AGENDA

2. 22-0014 Halifax Self Storage

CITY OF COLUMBIA TENNESSEE
 ARCHITECTURAL DESIGN REVIEW
 STAFF REPORT

ART 22-0014

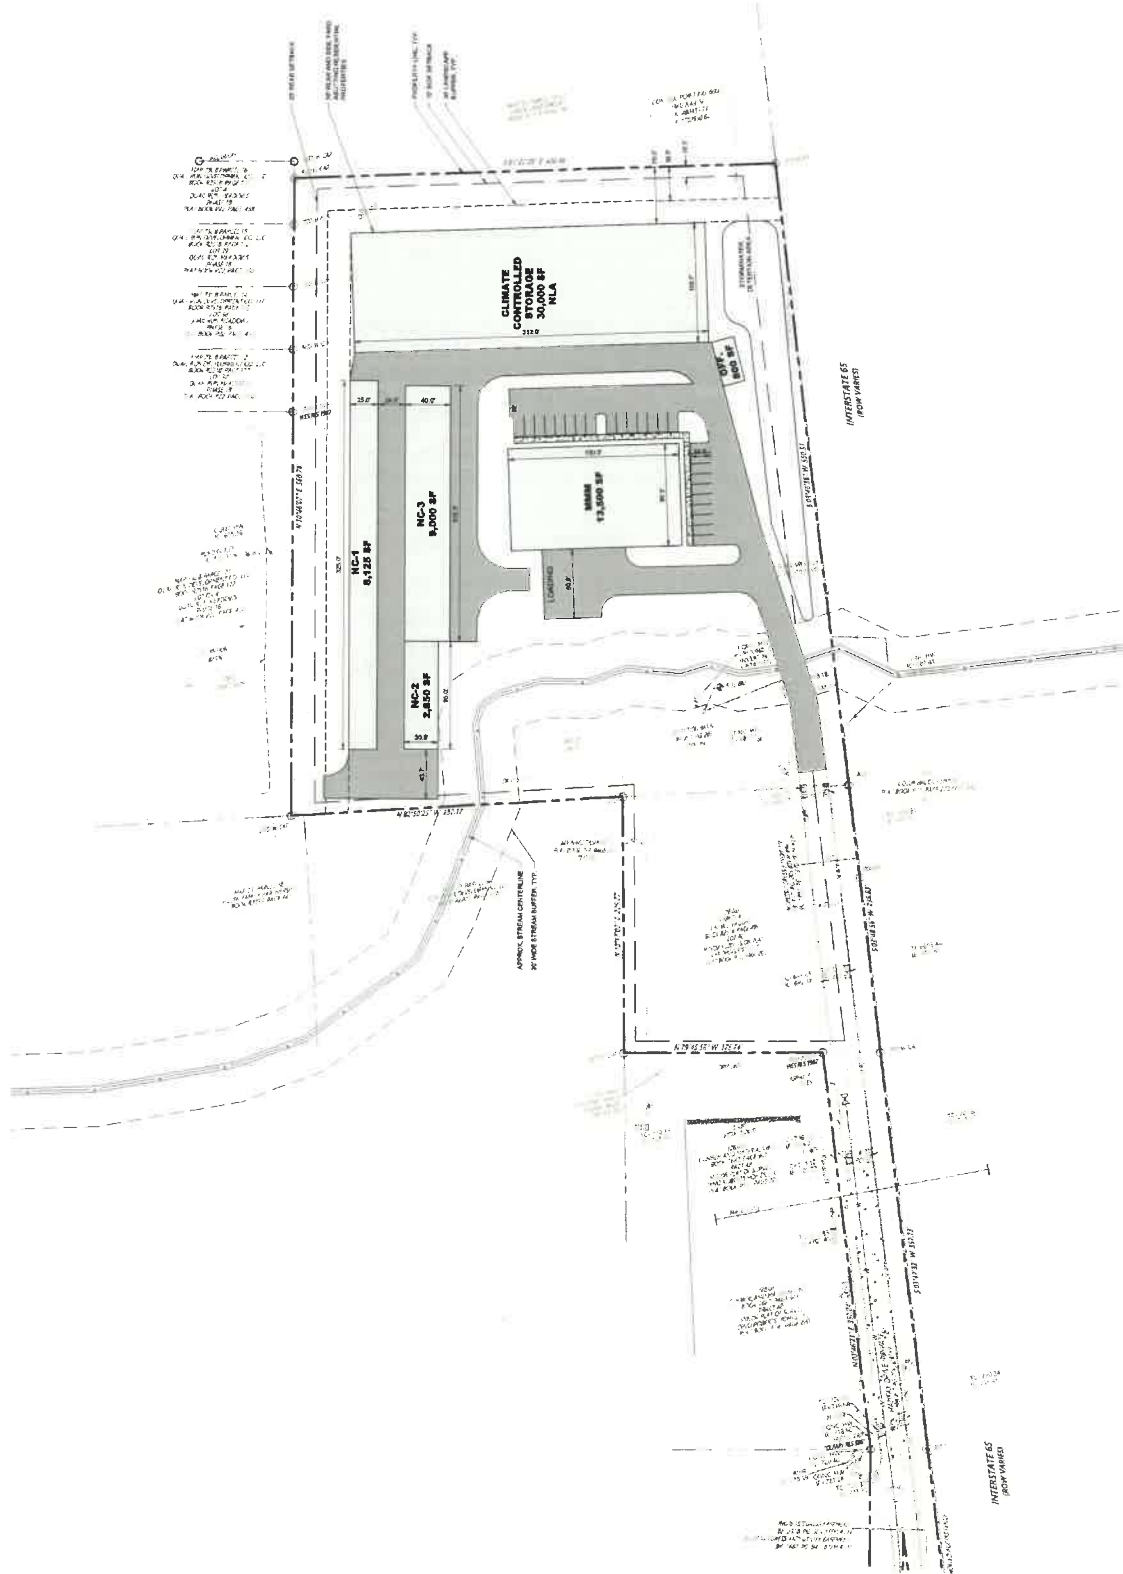
This request includes five storage buildings with all buildings having a façade material of fiber cement board (*Hardie Plank*). Please refer to attached site plan for reference.

- Building NLA will comprise of a 105 X 312 indoor self-storage structure with a maximum gable height of 20'. The façade material for the structure will consist of fiber cement board siding accented by fiber cement clad pilasters every 32'. This proposal would meet the guidelines as described for material and articulation.

- Building MMM will consist of a 90 X 150 structure with a maximum height of 19'6" at the gable. The façade material on the structure will consist of fiber cement board siding accented by fiber cement clad pilasters every 35' on the north and south elevation, with fiber cement clad pilasters every 27' on the east and west elevation. This proposal would meet the guidelines as described for material and articulation.

- Building NC-1 will comprise of a 25 X 325 structure that will serve as self-storage units with exterior access by roll-up doors. The façade material of the structure will consist of fiber cement board siding accented by fiber cement clad pilasters every 28'4" on the east and west elevations, with fiber cement clad pilasters every 28' on the east and west elevation. This proposal would meet the guidelines as described for material and articulation.

- Building NC 2-3 will be a 40 X 225 structure with an additional inset of a 95 X 30 self-storage structure. The façade material of the structure will consist of fiber cement board siding accented by fiber cement clad pilasters every 28'4" on the east and west elevations, with pilasters every 28' on the east and west elevation. This proposal would meet the guidelines as described for material and articulation.

- A 20 X 40 office building will be located on the site with a primary façade material of fiber cement board siding. This proposal would meet the guidelines as described for material. The façade has two window inserts.
